PLANNING COMMISSION AGENDA

TO: Planning Commission
FROM: Eric Zuzga, Director of Community Services
DATE: June 14, 2023
SUBJECT: SLU# 23.02- 902/1102 West Hanover Street Special Land Use

TO: Planning Commission
FROM: Eric Zuzga, Director of Community Services
DATE: June 14, 2023
SUBJECT: SP# 23.04- 902/1102 West Hanover Street Site Plan

SUBJECT: 902/1102 West Hanover Site Plan

CATCHMENT LEGEND

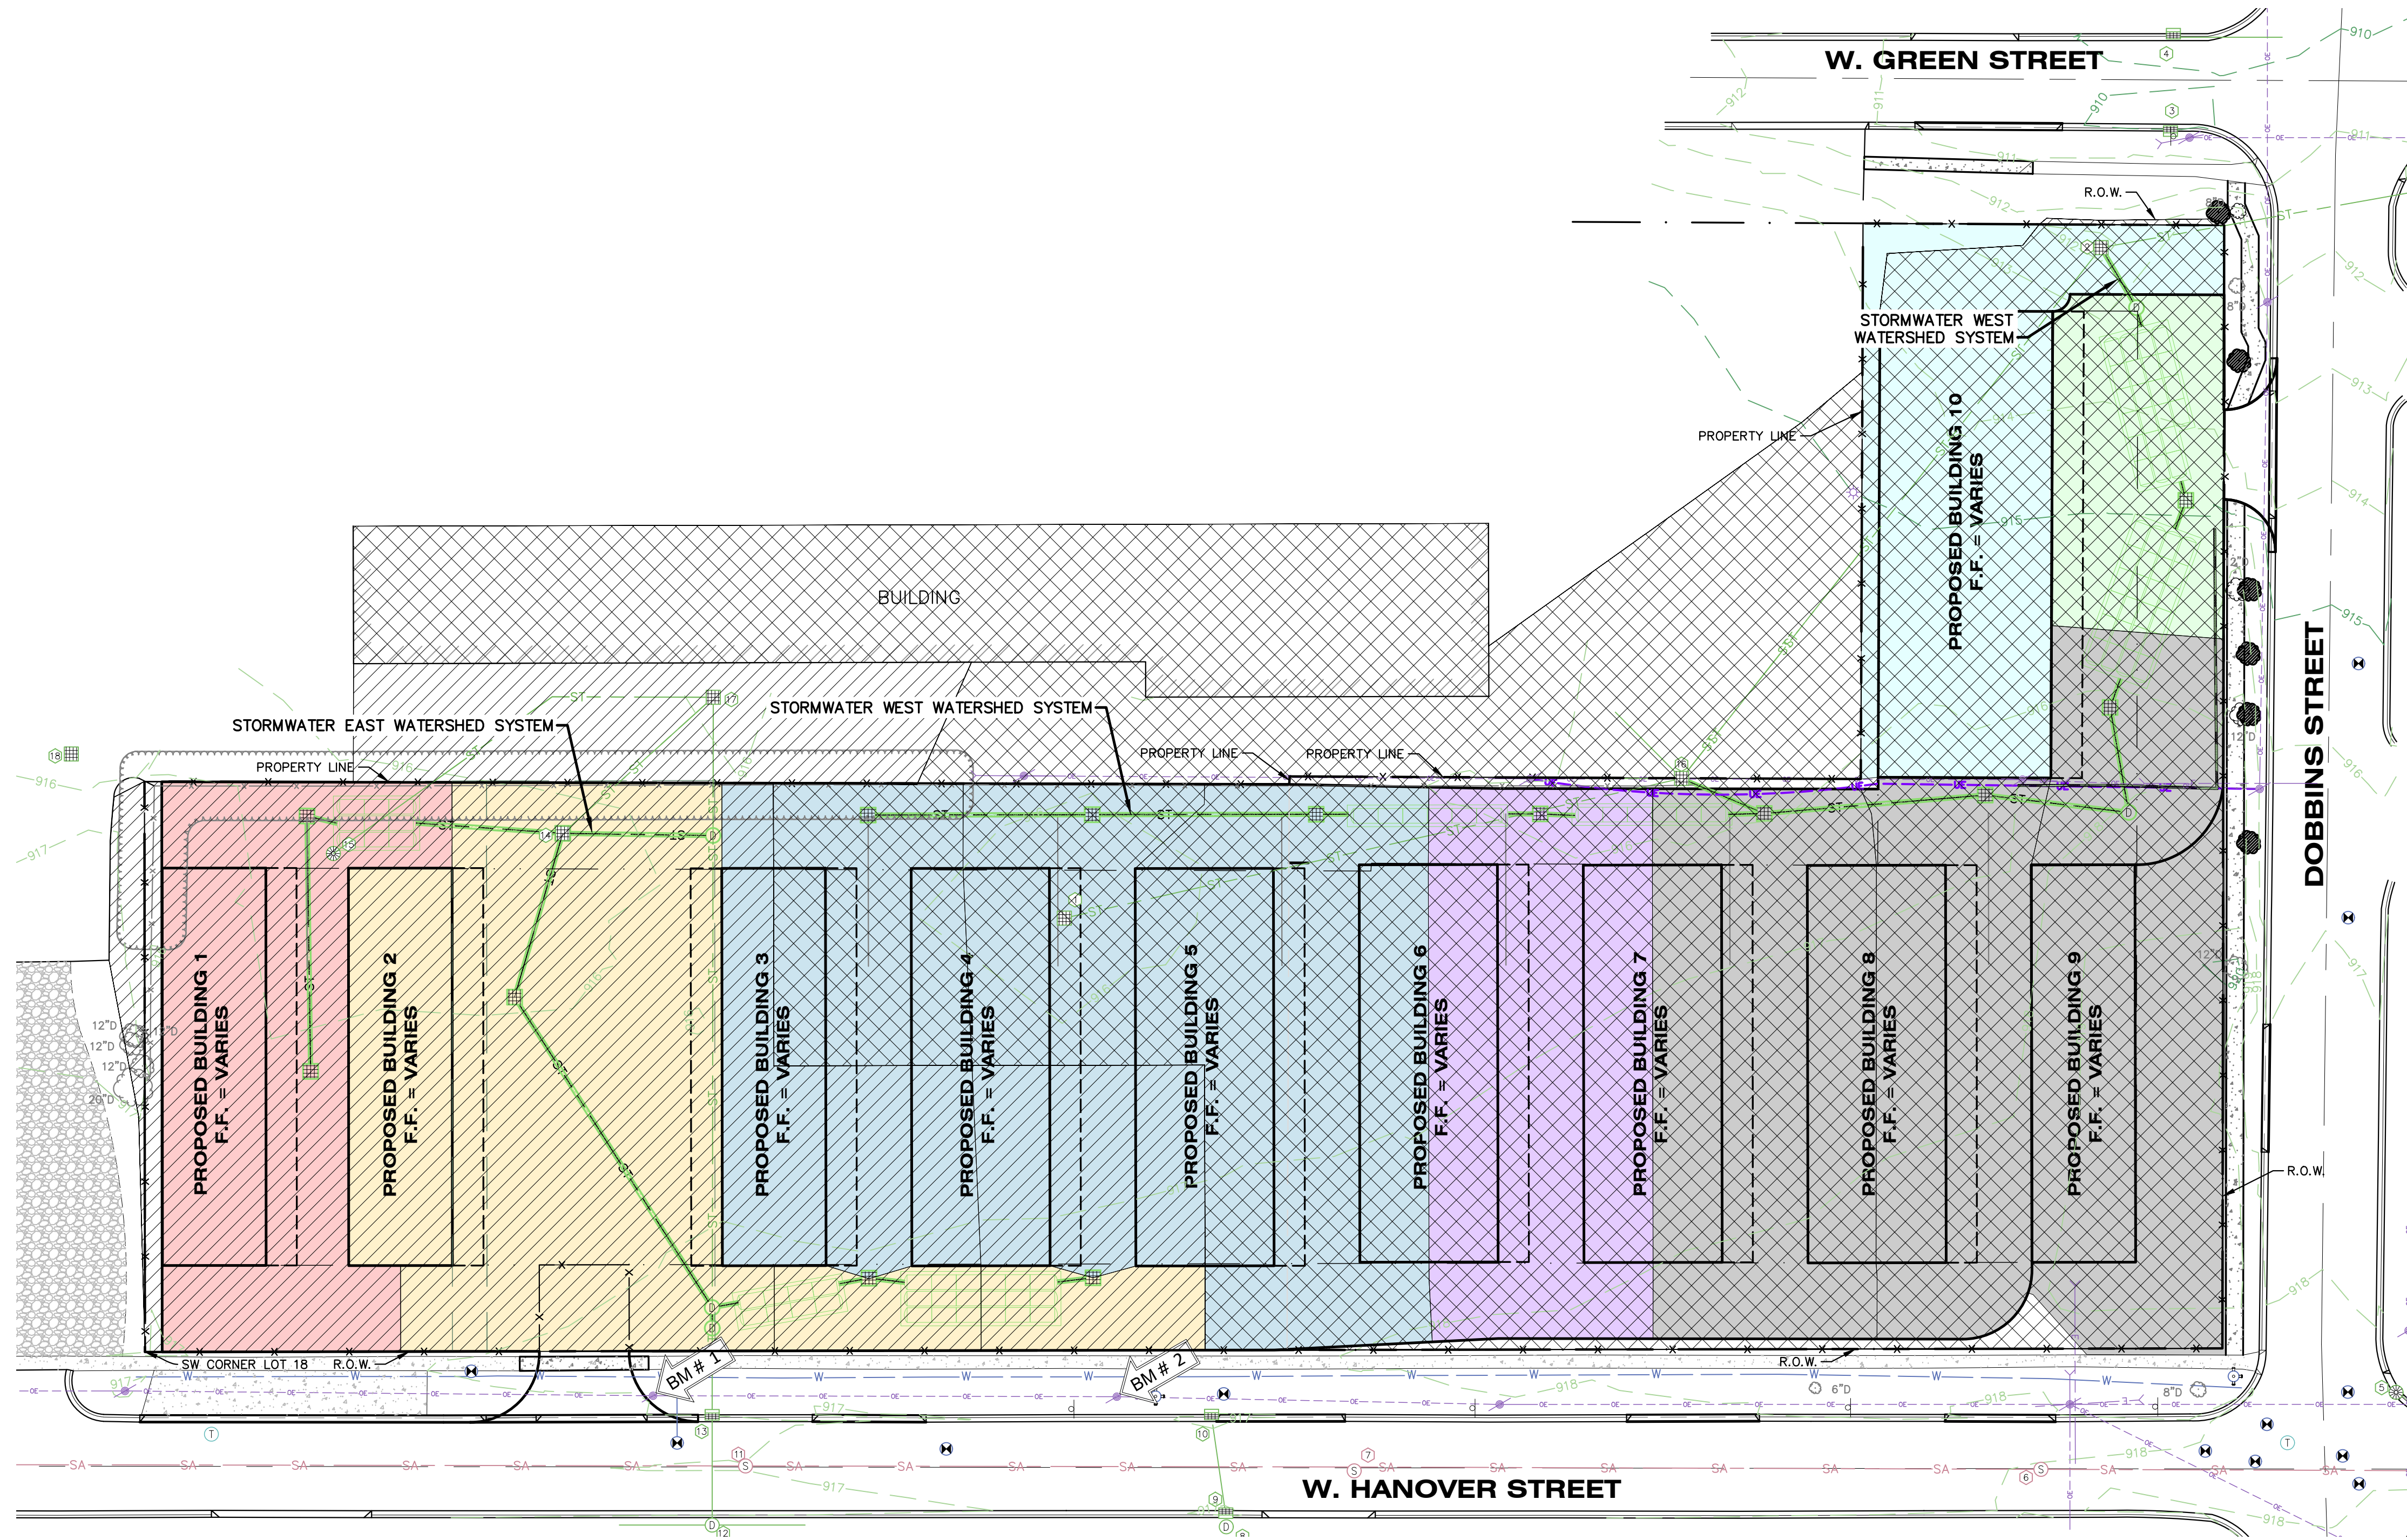
1. See comments in attached stormwater calc document.
 - a. Provide drawing defining existing watershed
 - b. See comment 2 in email –
 - c. No labels to identify ‘sets’ of chambers
 - d. Numbers do not match stormtech provided calculations
 - e. What structures on the plans do these devices relate to?

3. Provide a drawing outlining the 8 watershed areas with acres of each labeled.

4. For clarity – please label “stormwater – east” and “stormwater – west” on the plans to align with the stormwater calculations.

Response: The existing watersheds have been shown on sheet C-7. The volumes on the stormtech sheets do match the numbers provided in the required storage volumes. The stormtech volume sizing sheets start at the bottom of the stone elevation, which is selected in the header of the sheet. There are 9 inches of stone below the bottom of the chamber. This corresponds to 0 for the height of the system. Looking at the standard detail for the stormtech chambers, we have 9 inches of stone, reaching the bottom of the chamber. The SC-740 chambers are 30 inches tall, which is then covered with 6 inches of stone. This results in a total height of 45 inches for the system. The provided volumes at 45 inches correspond to the required storage volumes in our calculation sheets. The corresponding structure numbers have been updated in the storm calculation sheet. The outlet control structures are STM # 1 and STM # 12.

Response: This drawing has been provided on the new sheet, C-7.

Response: These labels have been added on sheet C-7.

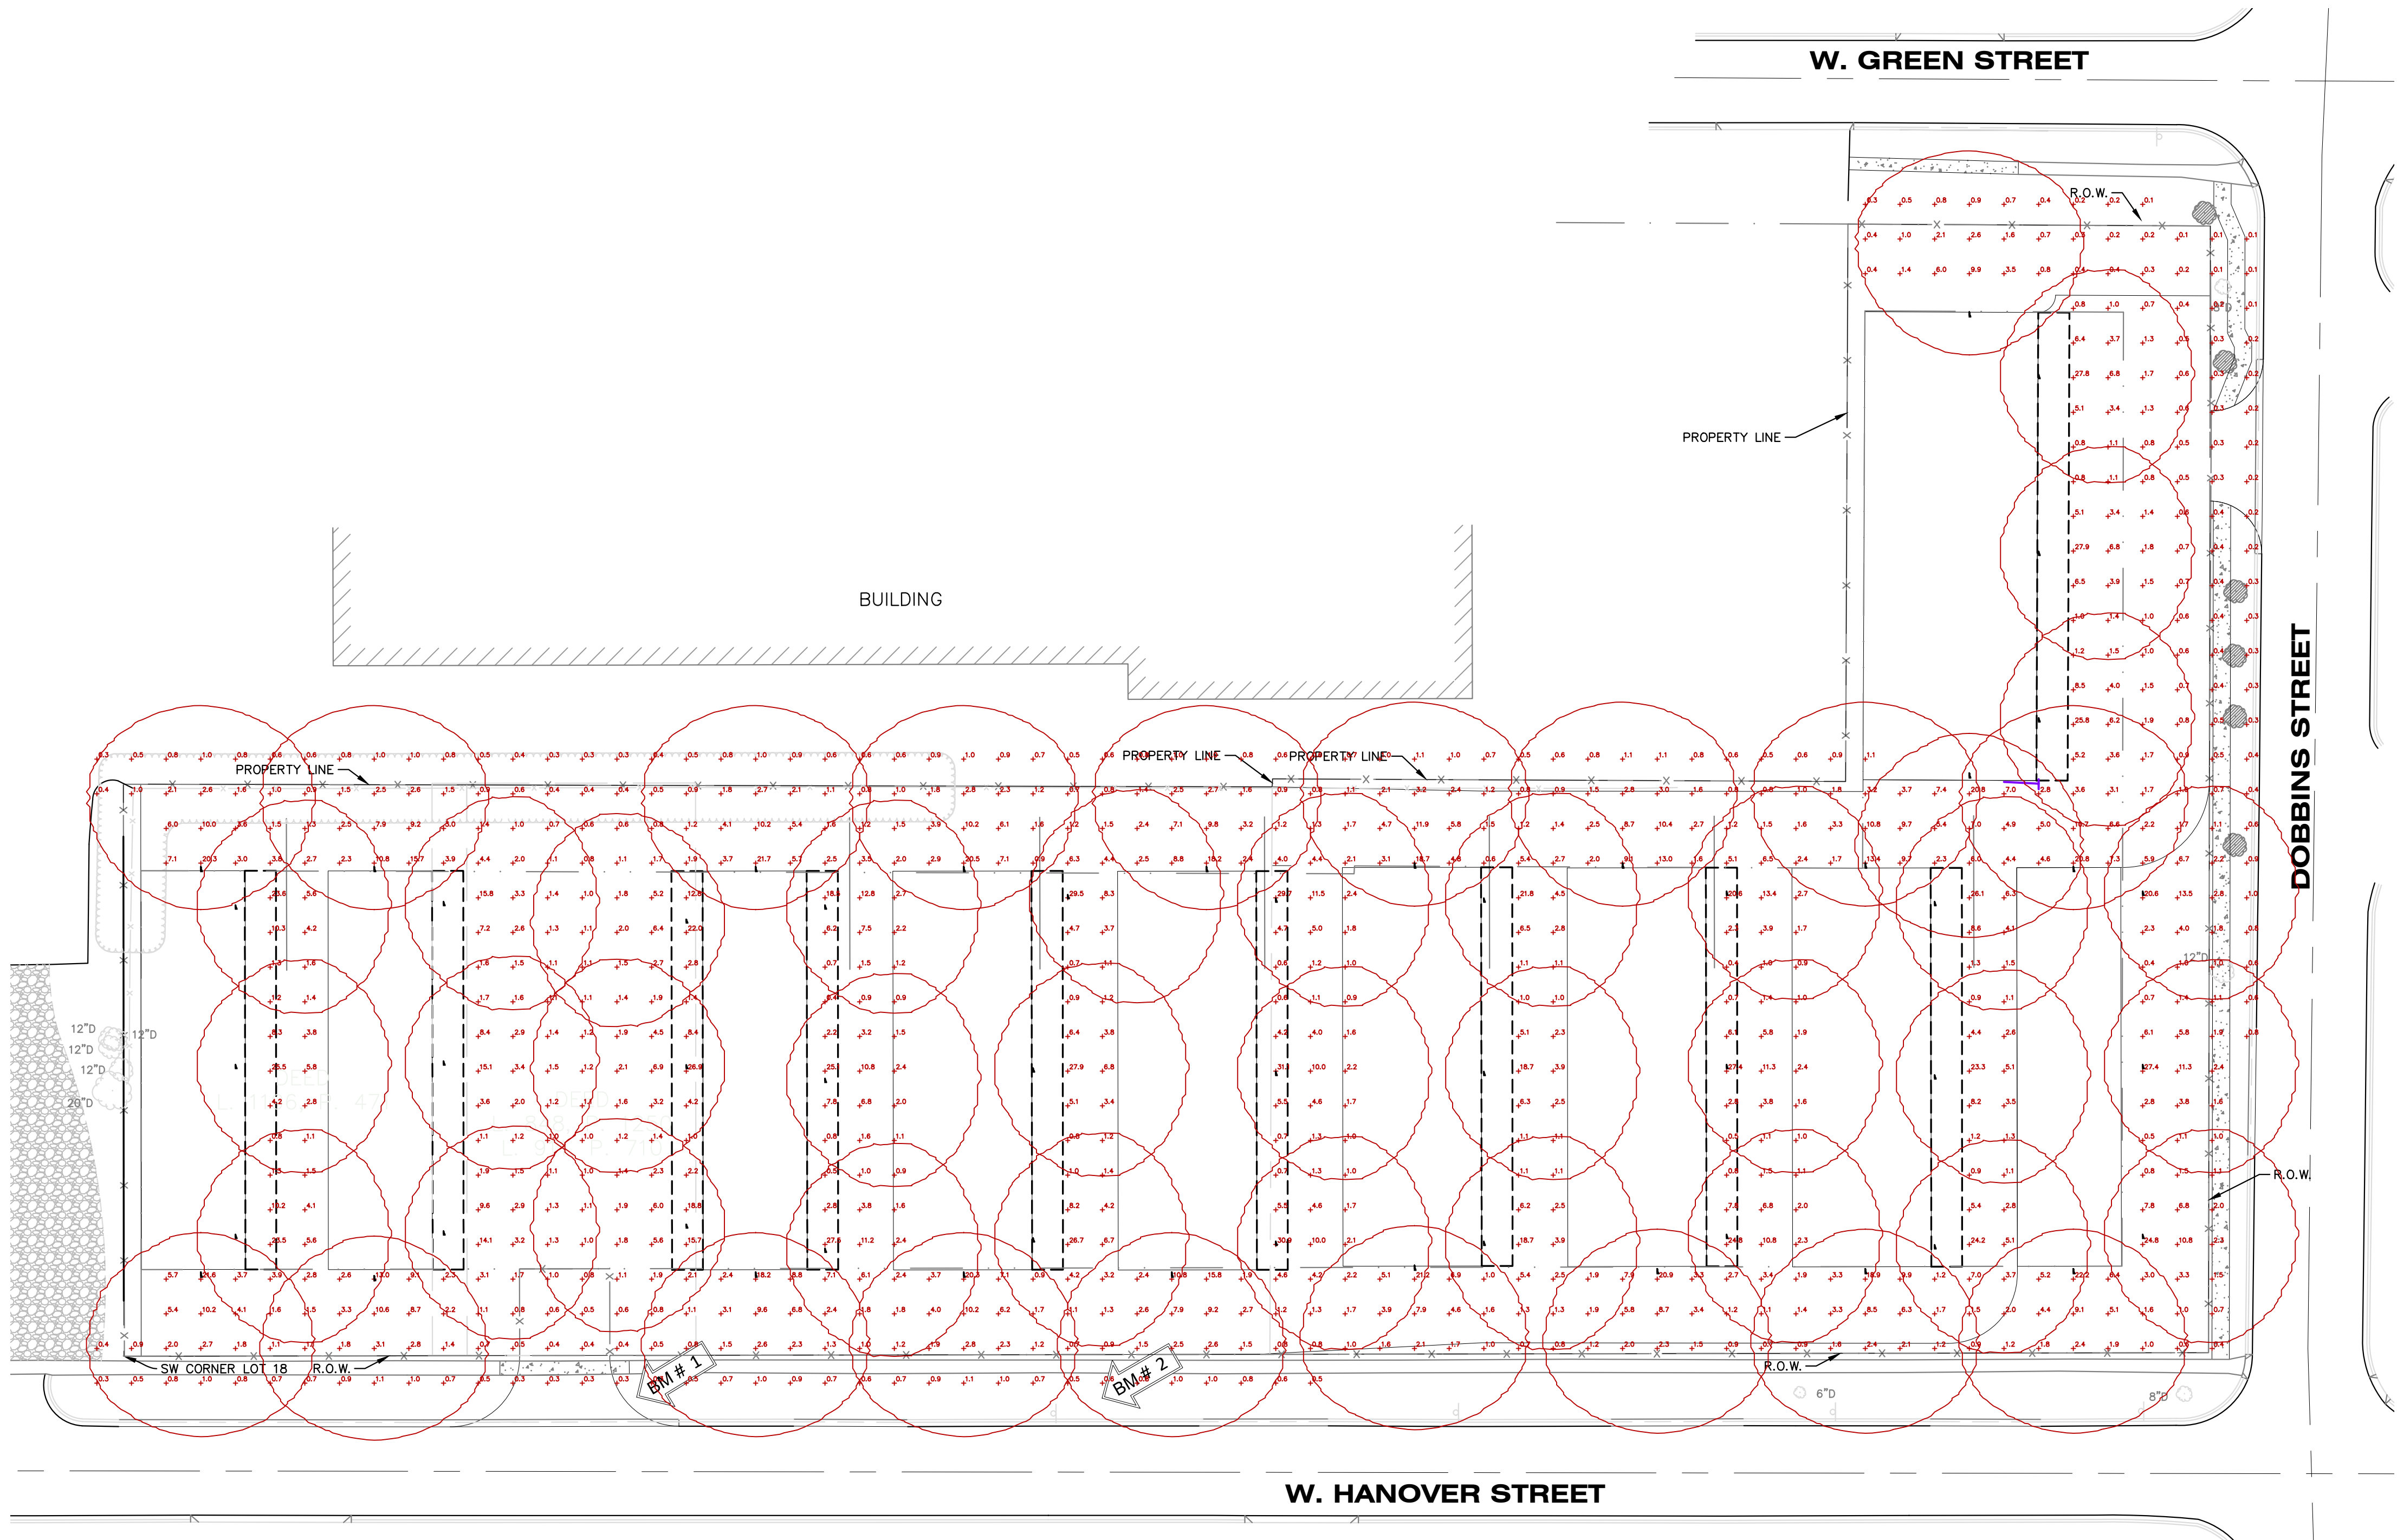
The required photometric plan was included with the submitted plans showing compliance at property line in most locations. Alley between Redfield Plaza and site has light trespass issues. Provided light pack needs further discussion at the meeting.

Dobbins and Hanover Street with locations approved by City staff, and exterior lighting plan would need to be reviewed at specific locations and the type of light used reviewed.
